Matter: City Place Site Plan / Ann Arbor, Michigan / City File No. SP09-07

Subject: **City Place Site Plan / Ann Arbor, Michigan / City File No. SP09-07**  
**Our File Number 1096.000**

May 28, 2009

Please find below my analysis of the City Place Site Plan submittal. The purpose of my review is to address the Germantown Neighborhood Association's concern that City Place might not fully conform with the Ann Arbor Zoning Ordinance. Although there has been quite a bit of debate regarding the appropriateness of the development and the current zoning processes, those are not the subject of this review. This review will focus solely on the requirements of the current Ann Arbor Site Plan and Zoning Ordinances.

Illustration 1: West Elevation facing 5th Avenue. (Composite based upon City Place Site Plan submittal sheet A3.9b. Material notes have been removed for clarity and the dimensions string moved.)

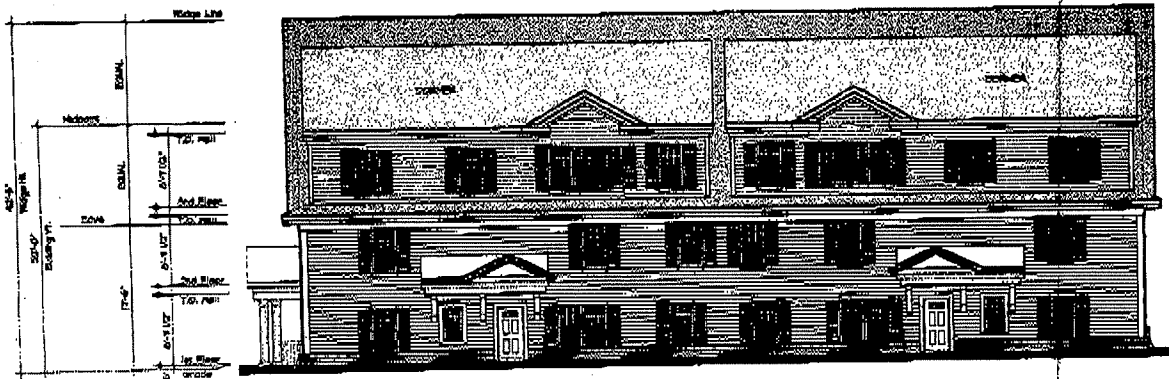
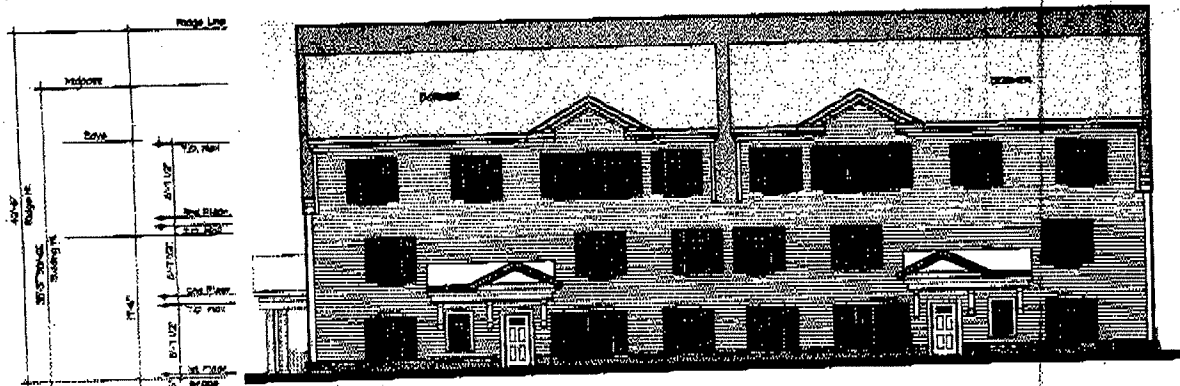
In this drawing the building appears to be a two-story structure with two large dormers set into a roof with the eave line occurring at the top of the second floor. The definition critical to the building height measurement is the 'eave'. The Ann Arbor Zoning ordinance does not have definitions for roof, dormer or eave, however common definitions from the Merriam-Webster Online Dictionary are:

Based upon these common definitions, the eave is a portion of the roof that extends beyond the exterior wall, therefore if the eave is removed, the roof will remain. The following illustration (illustration not created by the applicant) is an example of that logic as applied to this project.

This illustration demonstrates that the "dormers" do not "project through a sloping roof" and instead actually support the roof. The same can also be seen in the South Elevation (below) where the west (left) and east (right) walls are shown to be continuous from the foundation up to top of the third floor.

Together, the illustration and drawing show that the "dormer" structures are so large that they make up the highest percentage of roof area and should thus be considered the roof.

**Conclusion C:** The eave line for this project does not occur at the top of the second floor, it occurs at the top of the third floor where the bulk of the roof structure is supported therefore the actual building height is  $((42'-6'' \text{ [ridge]} - 28'-0'' \text{ [eave]}) / 2) + 28'-0'' \text{ [eave]} = 36'-3''$  which **EXCEEDS** the maximum allowable height of 30 feet.

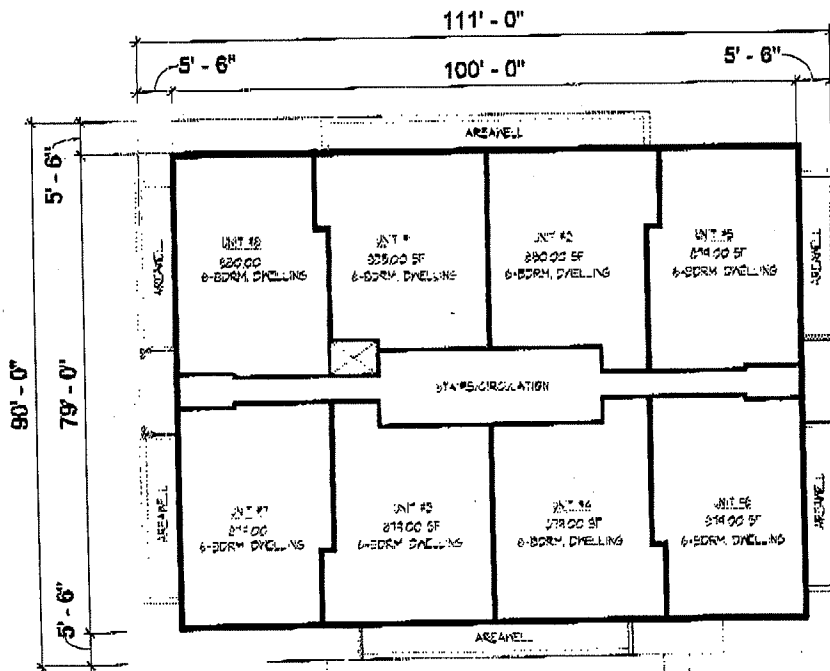
**ISSUE E. Required Setback Line Minimum, Chapter 55, Article III, Section 5:34 & Chapter 55, Article IV, Section 5:62:** The applicant has requested approval of the following setbacks for the South Building:

Proposed	Minimum Required = Permitted + Required Additional Setback (per applicant)
Front Yard	32'	32' = 25' + 7"
Side Yard		
Least of one	22.5'	16' = 12' + 4'
Total of two	34'	30' = 26' + 4'
Rear Yard	37.5'	37' = 30' + 7"

The Required Additional Setback calculation increases the minimum required setback for structures that exceed certain height, length and widths. A "structure" is defined as:

In accordance with this definition, the proposed "South Building" is 111 feet (length) x 90 feet (width). The dimensions were scaled from the drawings prepared by the applicant and are illustrated below (illustration not created by the applicant)

When calculating the additional setbacks, it appears that the applicant did not include the 'area wells' in the overall dimensions. The 'area wells' are fundamental structural elements of the building (since they are necessary to meet the light, ventilation and egress requirements of the Housing and Building Codes) and must therefore be considered when determining setbacks.

**Conclusion E1:** The South Building overall dimensions must take into account all elements of the building, including the area wells. Therefore, the front, side and rear setbacks have been **INCORRECTLY** calculated

Illustration 5: The dashed blue line indicates the property calculated and applied minimum setbacks. The red cross-hatching shows the footprint of the proposed structures.

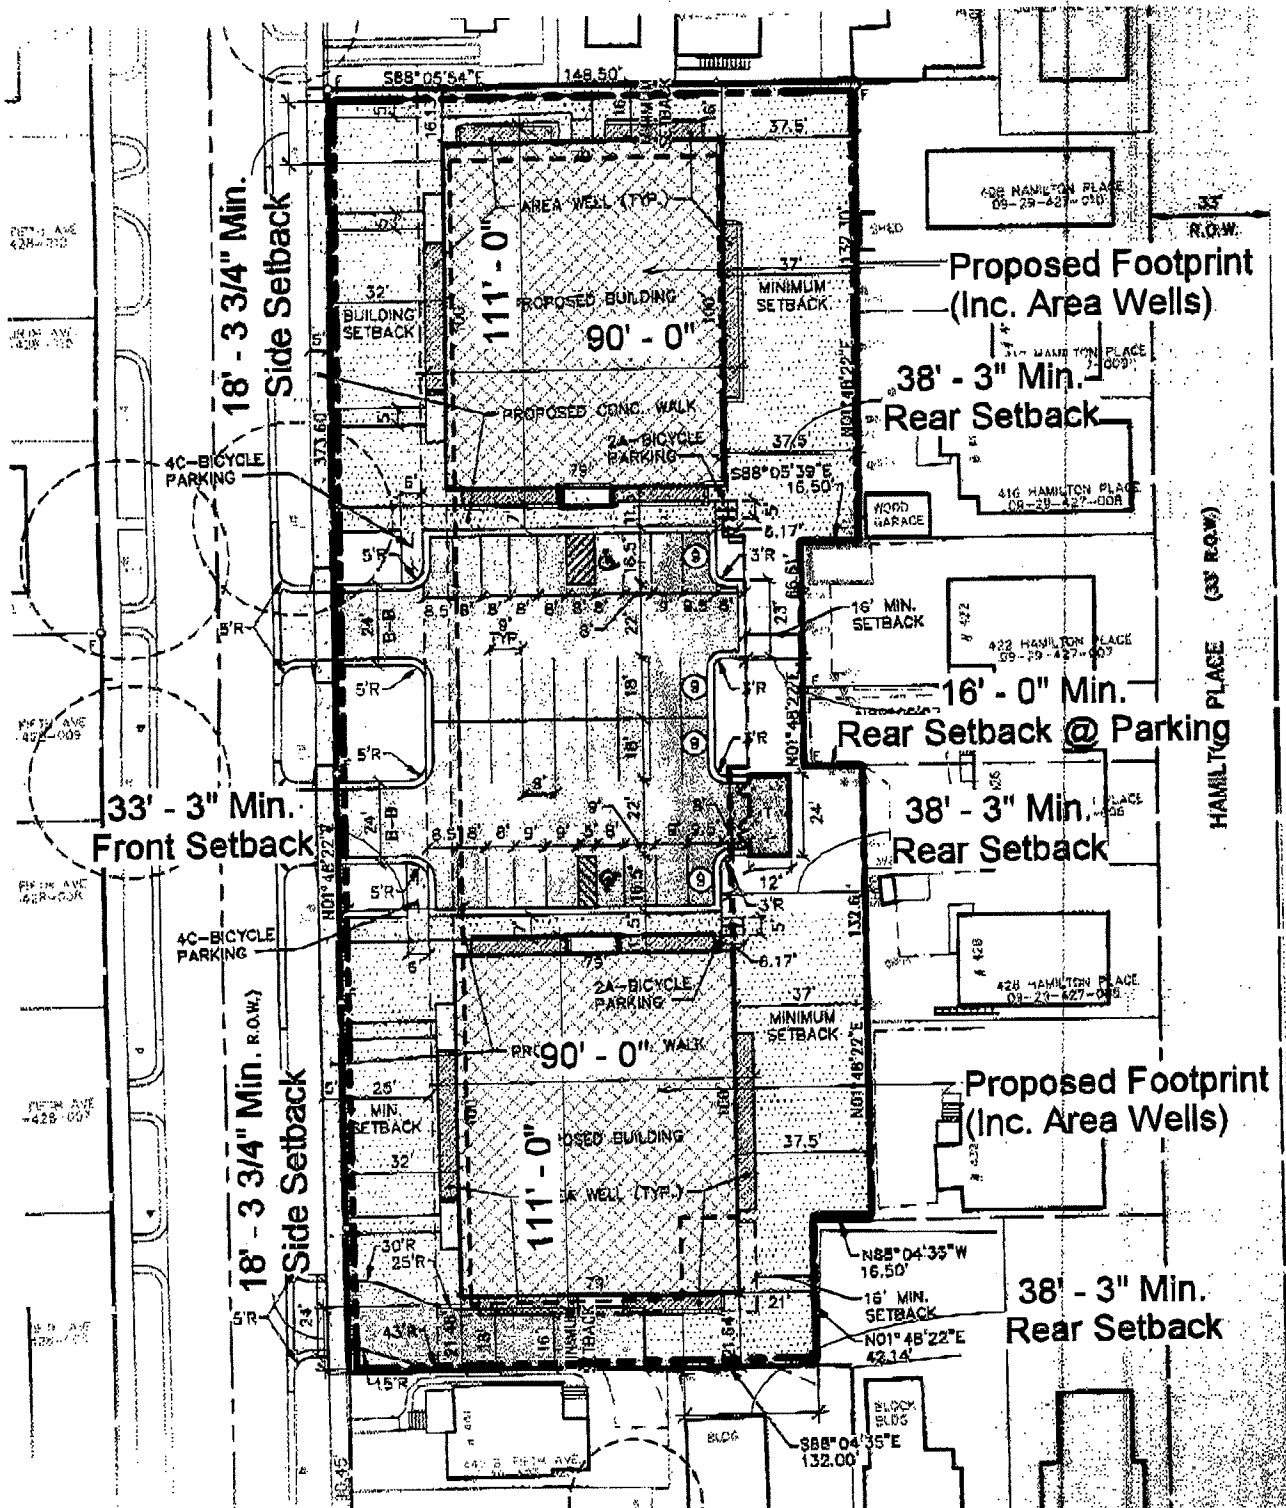
**Conclusion E2:** When all elements are taken into account, *the project VIOLATES the front setback by 6.785', the side setback by 2.42' and the rear (at the south east corner) by 17.8' as shown in the illustration on the following page (not created by the applicant).*

By not including the "area wells" within the building footprint, the applicant has placed them within the minimum required setback and thus into the required open space.

**Conclusion F:** The "area wells" are permanent structures and as such cannot be located within the Required Open Space. By locating them within the minimum required setback, *the project VIOLATES the Required Open Space.*
